Downstream Authority of the Quapaw Tribe of Oklahoma Regular Meeting
November 2, 2011

JCJ Review
Bill Dow/ Kristina Ennis

SITE LOGISTICS

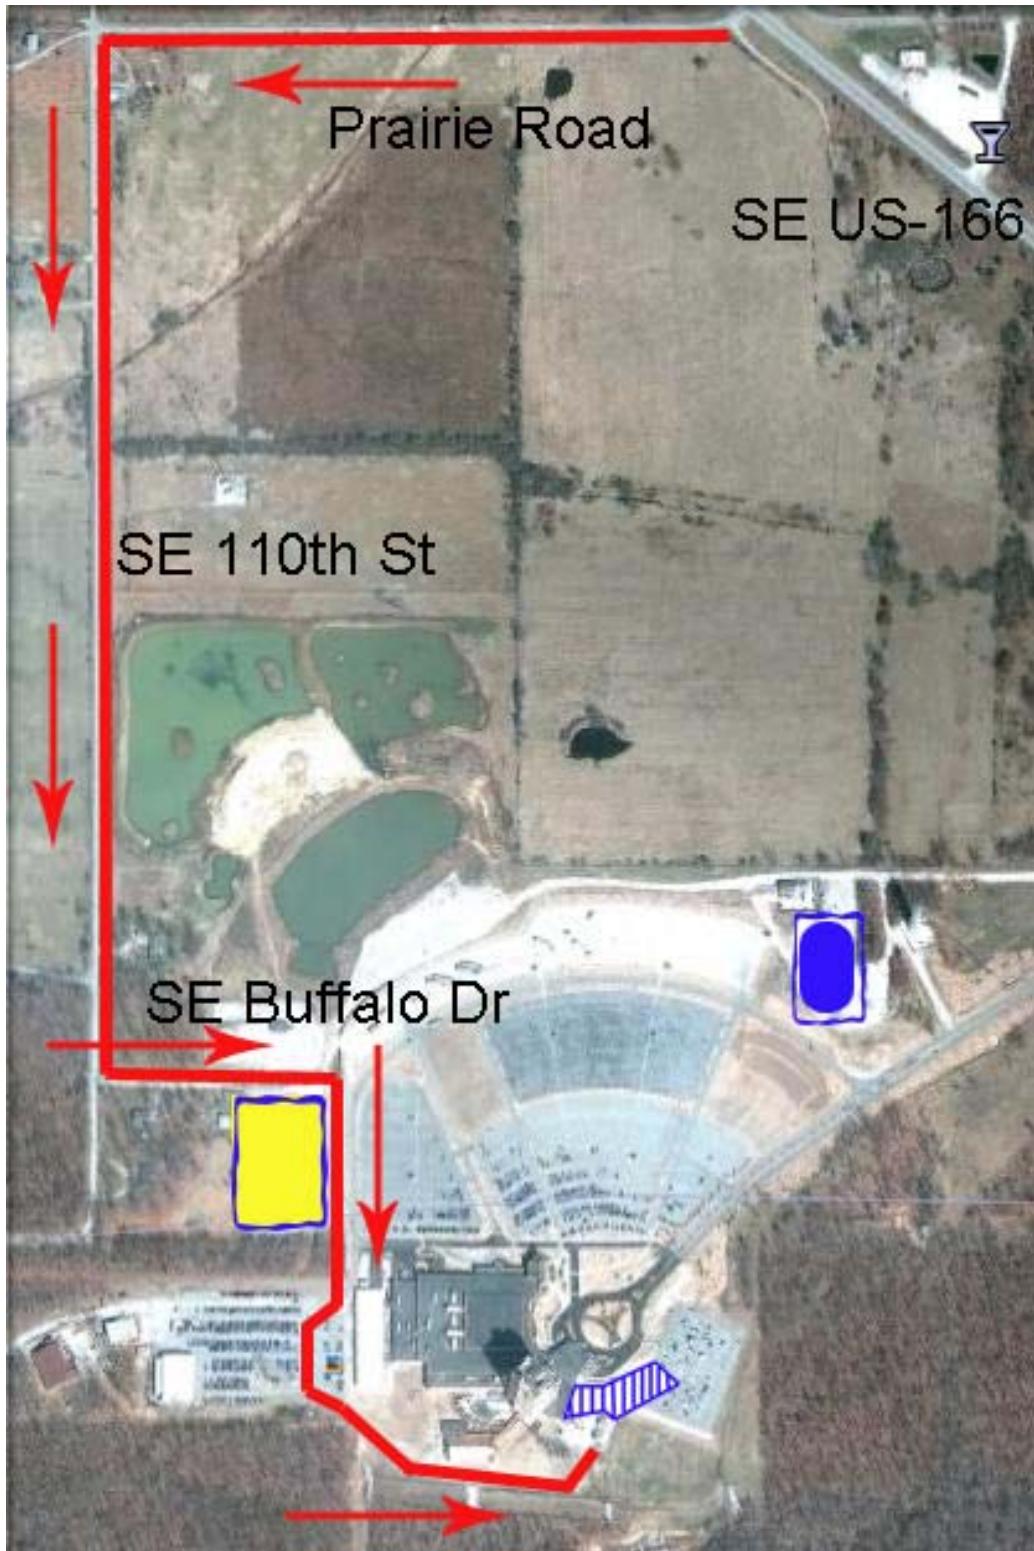
- o Add #7. Board room /meeting space.
 - o Reference Design Narrative for bid.
 - o Discussion of proposed placement of construction trailers. Concern with Skink Habitat.

- o Concern regarding construction traffic coming down 110th. No issue that requires change in traffic flow.
 - o Add licensing cost for Contractors to request for proposal.

PAVILLION STORAGE
BUILDING

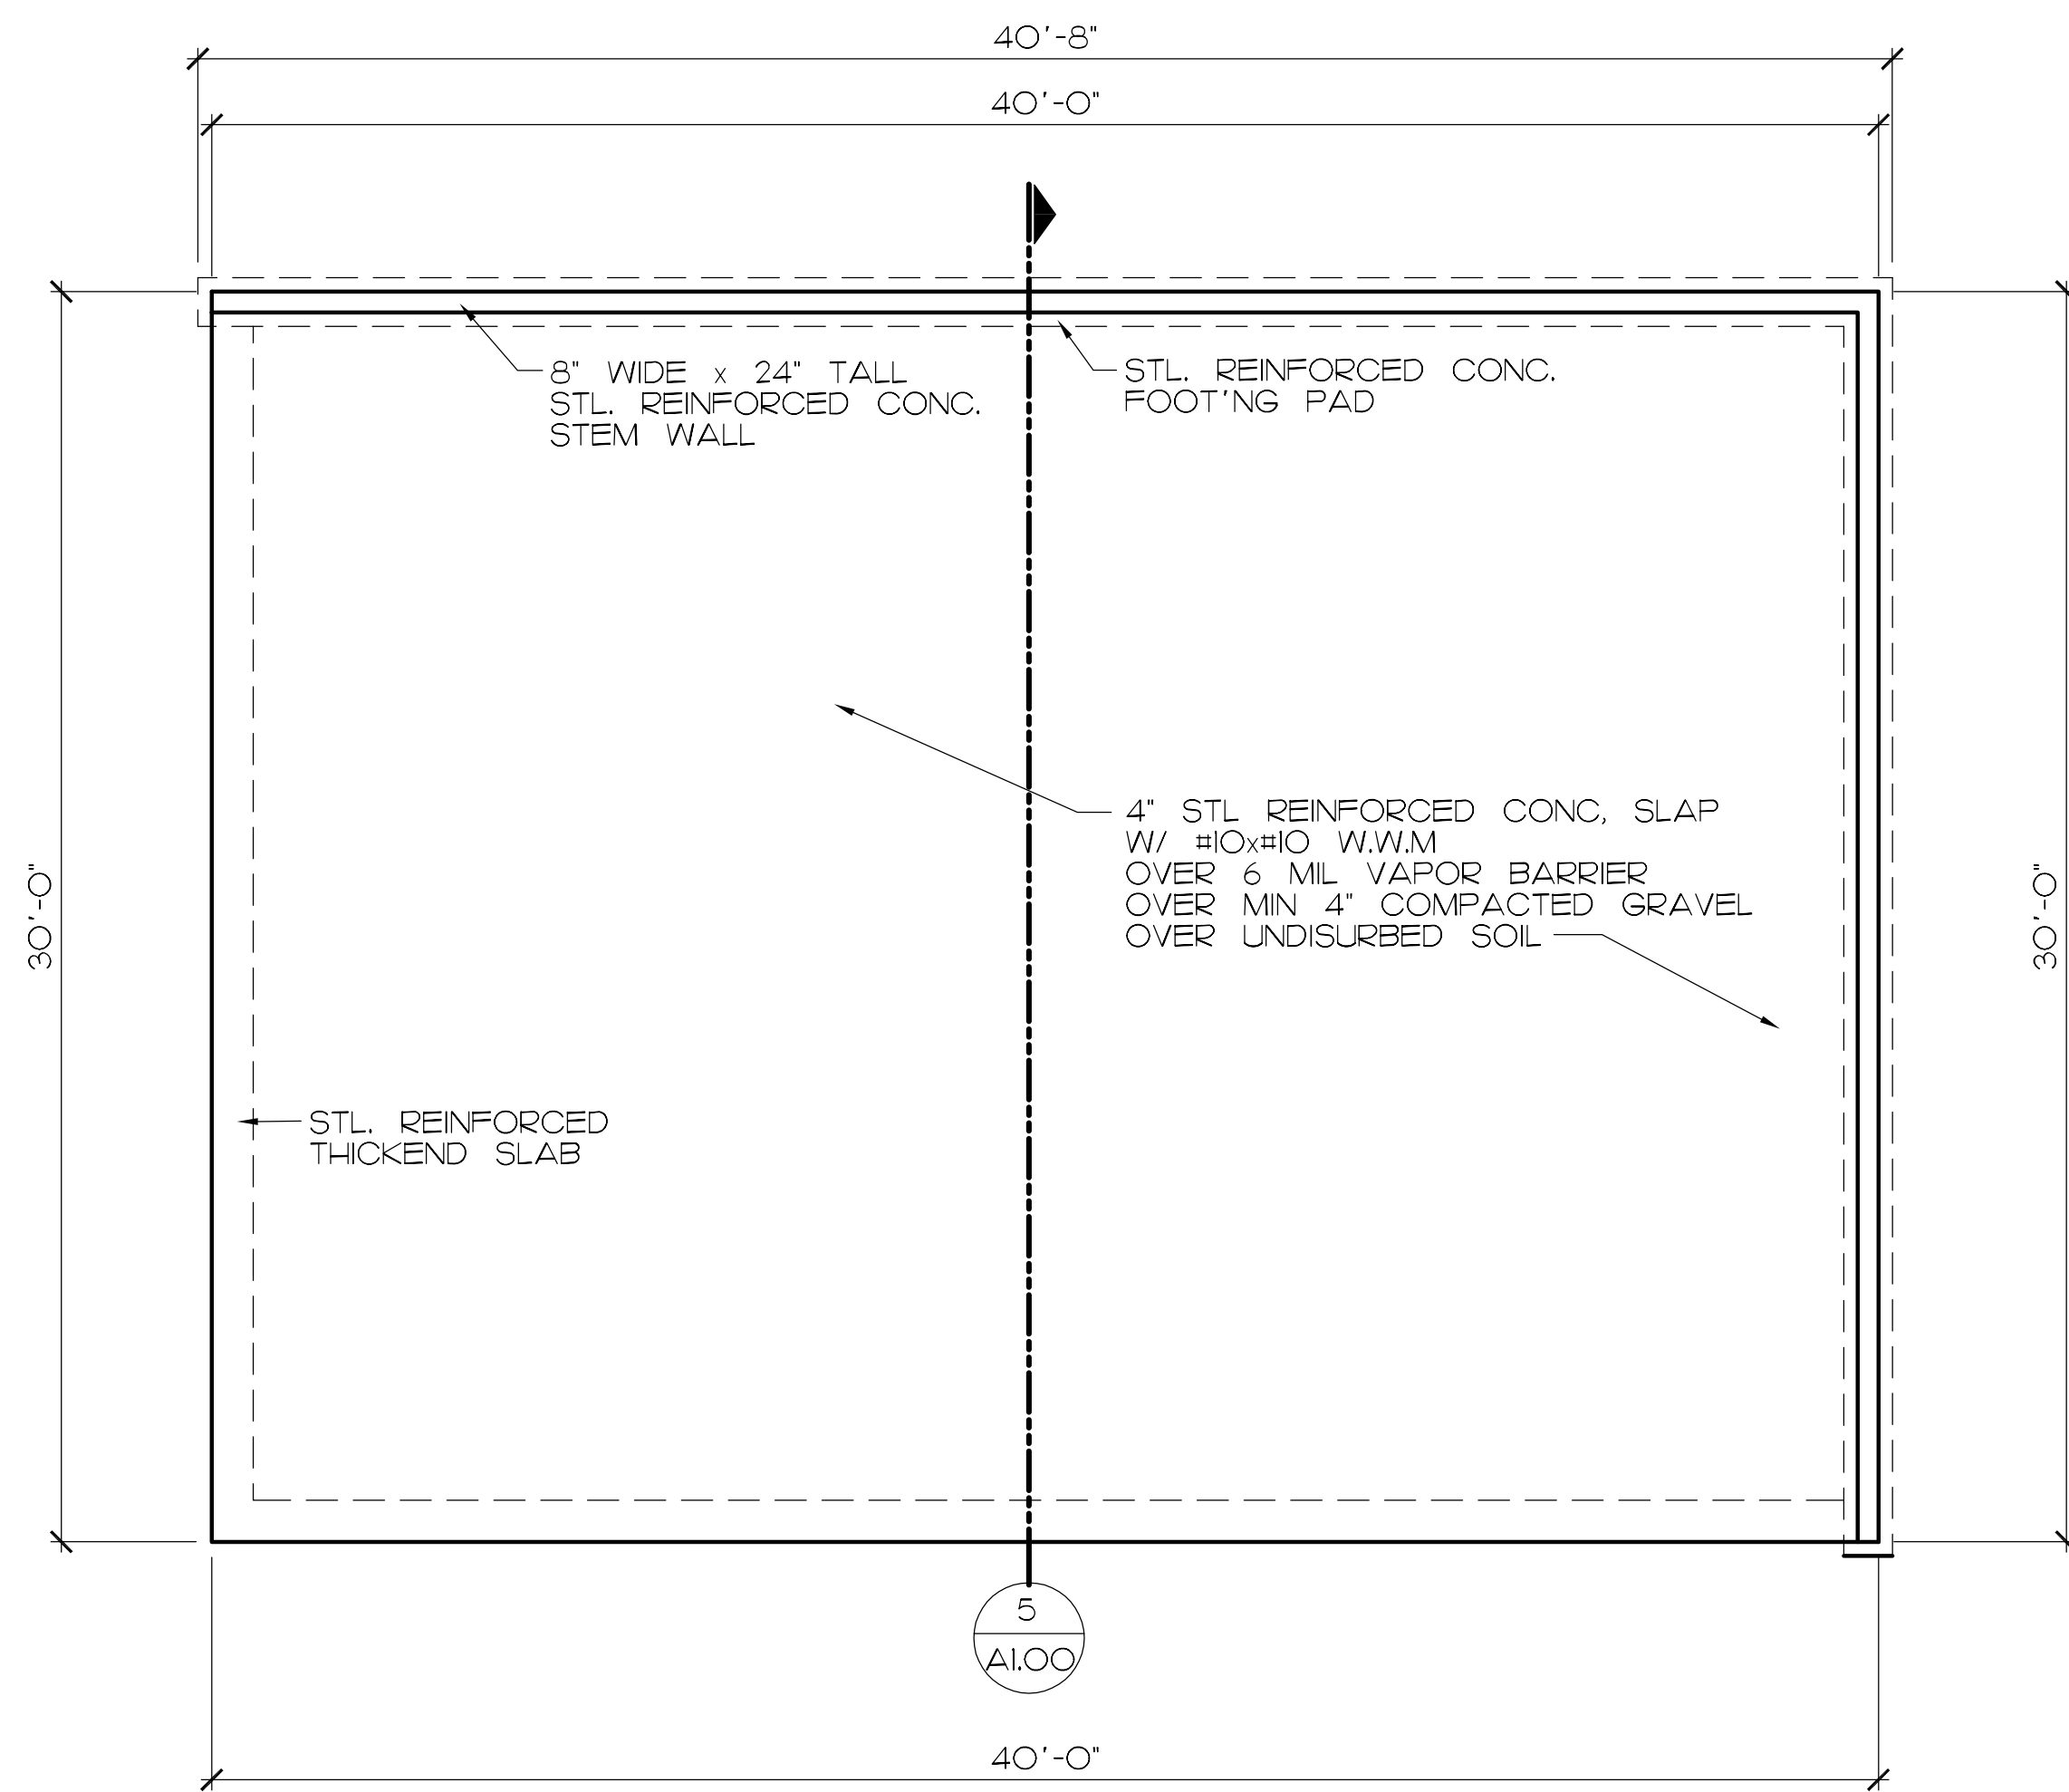
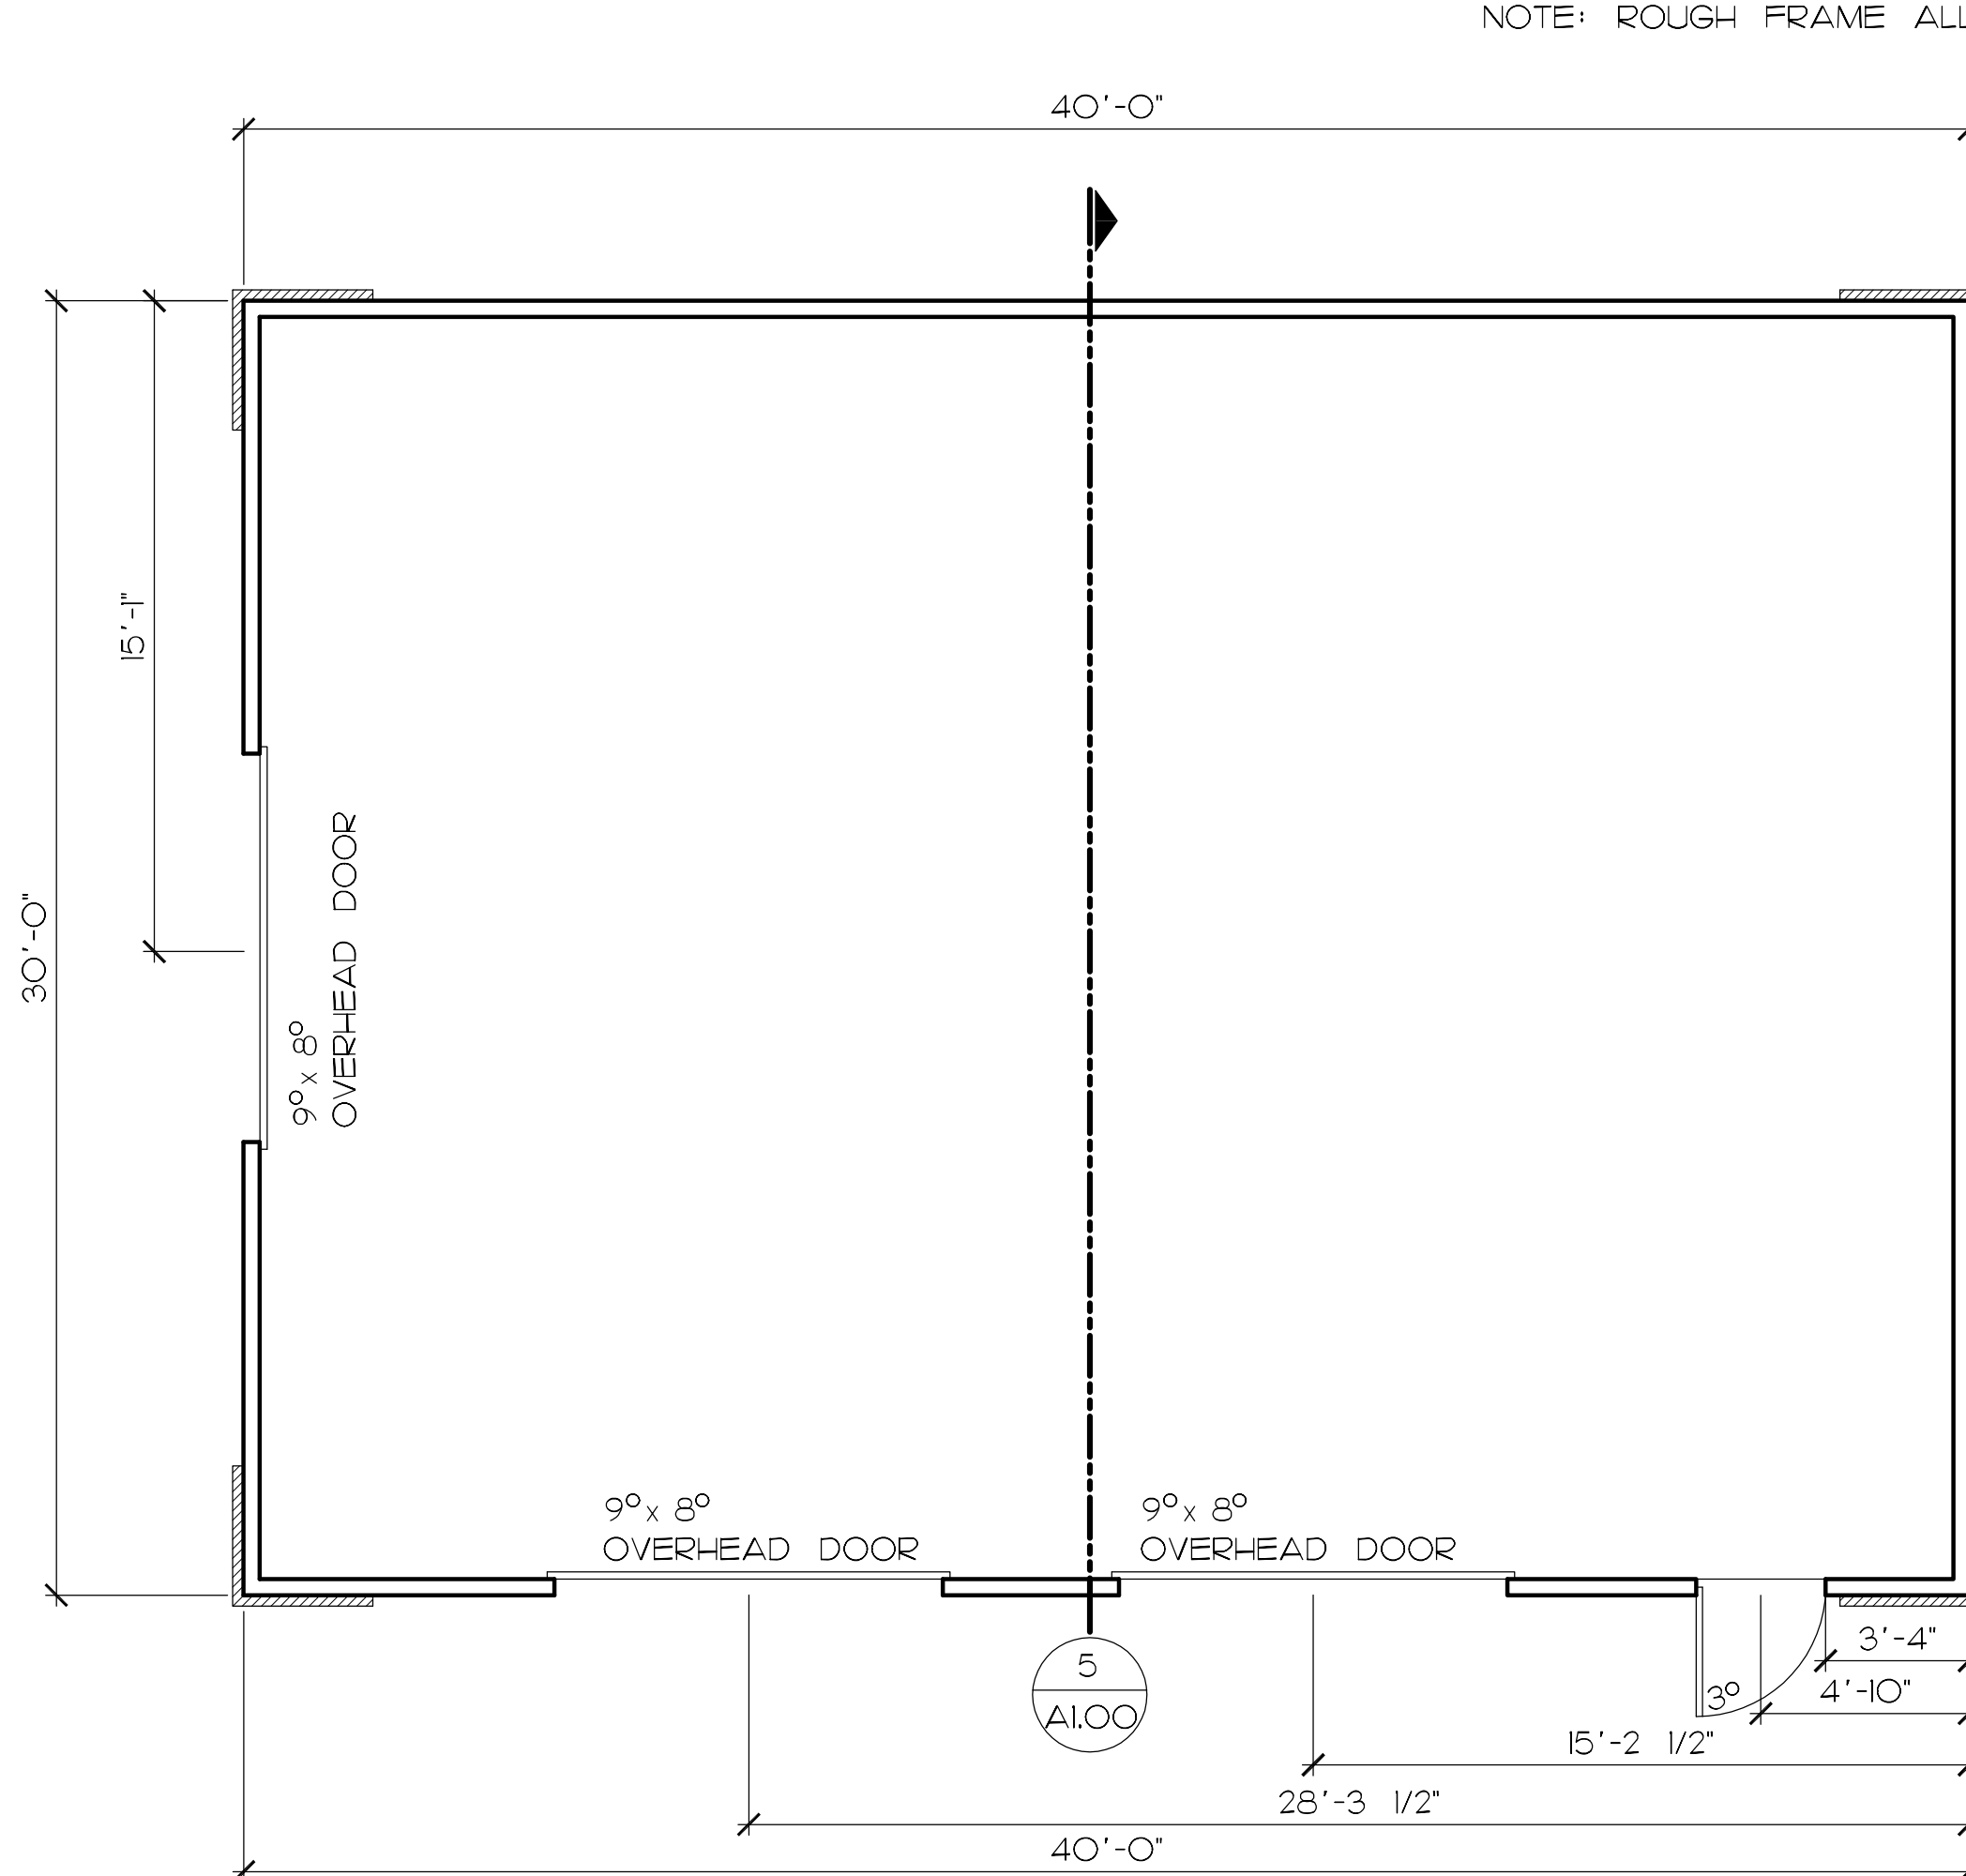
- o Review of building drawing that could be placed on grassy area beside/behind pavilion. Structure will be 30x40. Finishes will match pavilion: copper roof.
- o Doesn't need sprinkler. Building is 40' from corner of existing building. Can be stick frame.
- o Facilities can handle power.
- o Could use half for mock up and half for storage from the beginning. Ballpark # is pushing \$50K. Sticky stone or wainscot? 1 – 16' door vs. 2 – 8'.
- o Would like to move forward and have this built to be able to use before December. It is determined to move forward at least in pricing.
- o Chris Roper to have pricing for Mock up by end of this week.
